Installation Notice for Rr Shock Absorber

Rr Shock Absorber

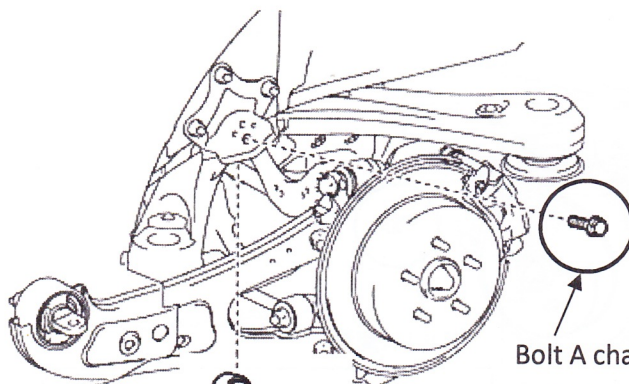
1. Please make sure to fully comprehend points below for replacement of Rr Shock Absorber.
2. Bolt A was also changed. Please use New Bolt (P/N91552-K1260) instead.

- Please use New Bolt(P/N 91552-K1260) for Bolt A during Rr Shock Absorber's installation.
- Please discard and do not use Old Bolt .

- Final tightening torque has been changed from 100N·m(1020Kgf·cm) to 90N·m(918Kgf·cm).
Please apply 90N·m(918Kgf·cm) to final tightening torque for New Bolt(P/N 91552-K1260) .

Bolt A → New Bolt(P/N 91552-K1260)
Torque: 100N·m(1020Kgf·cm)
→ 90N·m(918Kgf·cm)
